IMS Systems, Inc.
10521 Perry Highway
Suite 310, 3rd Floor
Wexford, PA 15090
Main: (724) 940-7160
Fax: (724) 940-7179

Hello Bill,

Item 2.3: Drawing 5321-035 A1 has the correct G18 Sintered Tungsten material listed. All other drawings that list S18 as the material will be revised, only to reflect the use of the G18 material. The drawings, after revisions will be available to the NRC for your review, if requested. (Dwg. 5321-035 A1 attached).

Compact cylinder, double acting
156003
ADVU-25--P-A

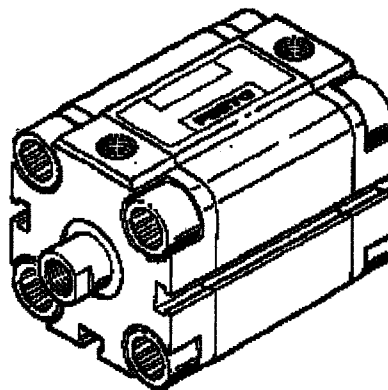
Item 7.2: The air pressure we require is between 4.5 and 8 bar, although all of the components including the shutter actuator are designed and approved to operate with 10 bar.(see attached file). I can explain why page 7 of the application indicates that the shutter actuator is limited to 8 bar. We require that the customer supply a minimum of 4.5 bar and a maximum of 8 bar. This gives us the ability with the pressure regulators and filters to regulate for the optimum performance of all the peripheral devices associated with the measuring system.
